Historic Landmarks Committee
ZOOM Online Meeting
January 5, 2021 3:00 PM

| Committee Members | Agenda Items |
|----------------------------|---|
| John Mead, Vice-Chair | <ol style="list-style-type: none"> A. HL 4-20: Certificate of Approval for Alteration (Exhibit 1) 806 SE Davis Street B. HL 5-20: Certificate of Approval for Alteration (Exhibit 2) 225 NW Adams Street C. HL 7-20: Certificate of Approval for Alteration (Exhibit 3) 608 NE 3rd Street |

DATE: January 5, 2021
TO: Historic Landmark Committee Members
FROM: Chuck Darnell, Senior Planner
SUBJECT: PUBLIC MEETING: HL 4-20 (Certificate of Approval for Alteration) –
806 SE Davis Street

SD-3

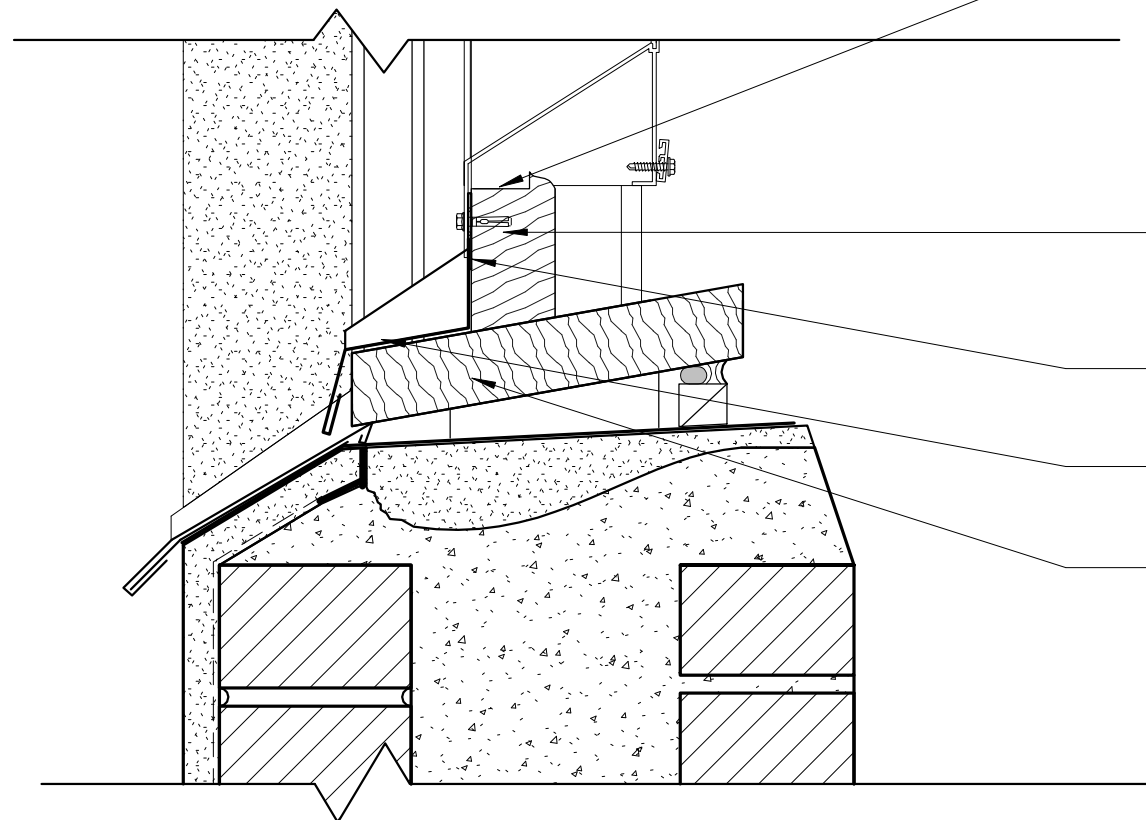
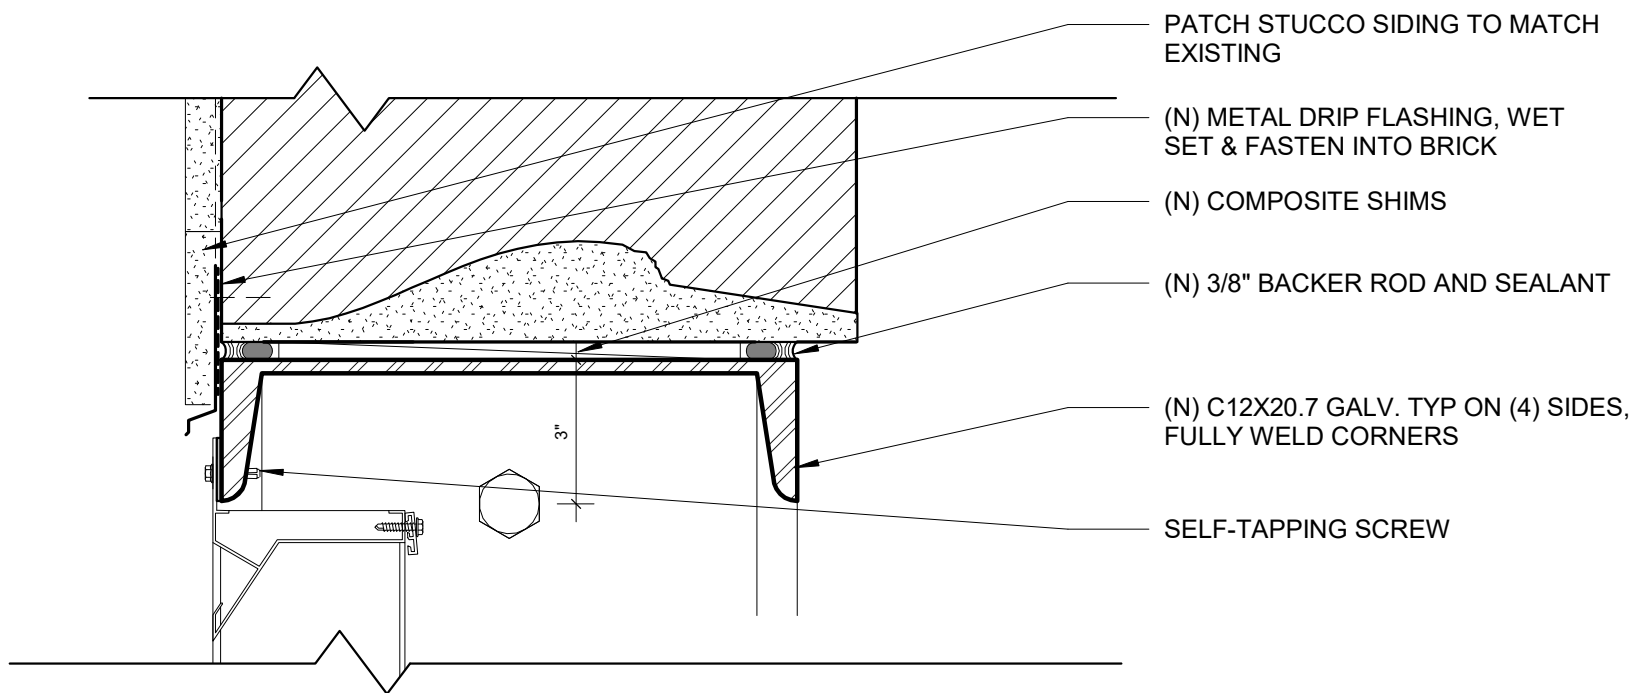
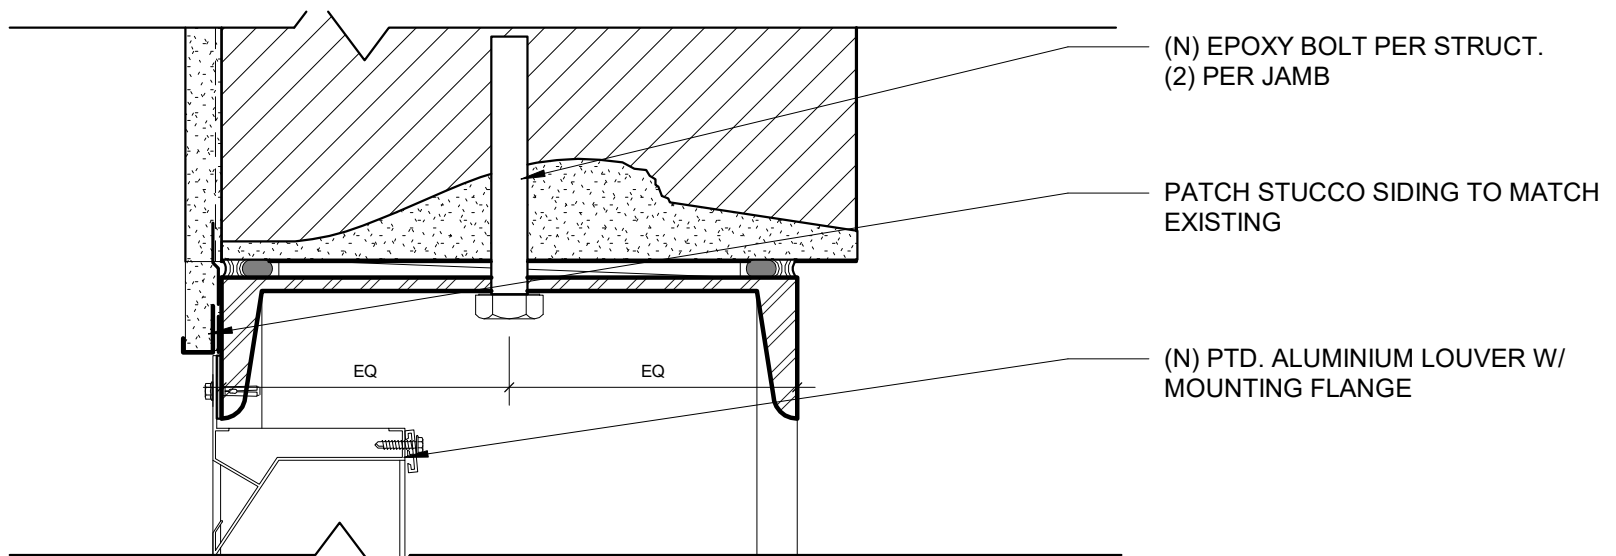
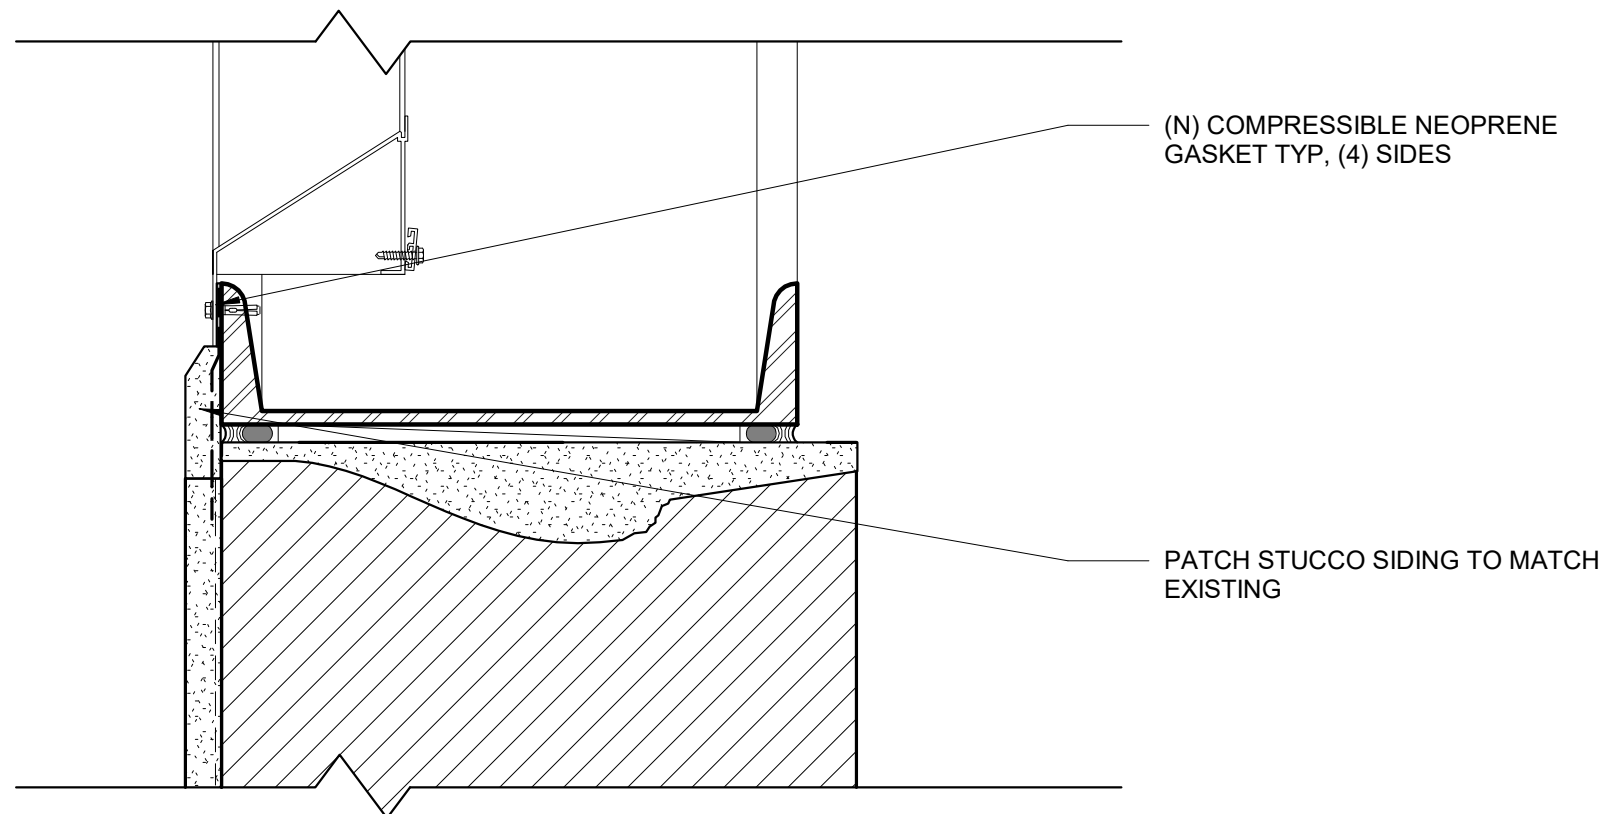
The City clarifies that the proposed alteration to add the two louvers to the building façade is not necessary to stabilize, consolidate, or conserve existing historic materials or features. However, the proposed method of construction for the louver that will be placed within an existing window opening will allow for the addition of one of the louvers without a new opening in the building wall. As proposed to be constructed in the details provided on Sheet SD-4, the proposed louver

FINDING: SATISFIED. The City concurs with the applicant’s findings, but adds that the proposed construction of the louver in the window opening, as shown in the details provided on Sheet SD-4, would allow for the louver be removed in the future and the window re-established, should the internal use of the building no longer require the ventilation provided by the louver. Other distinctive materials, features, finishes, and construction techniques present on the building will be preserved by directing the ventilation and the louvers to the alley façade that has already been altered from its historic form and materials.

A condition of approval is included to require that the louvers be finished as proposed in the application narrative. Specifically, the louver that will be in a new opening in the building façade shall be constructed as identified on Sheet SD-5 and shall be painted to match the color of the surrounding stucco on the building façade. The louver that will be in the existing window opening shall be constructed as identified on Sheet SD-4 and will be painted to match the color of the remaining windows on the south building façade.
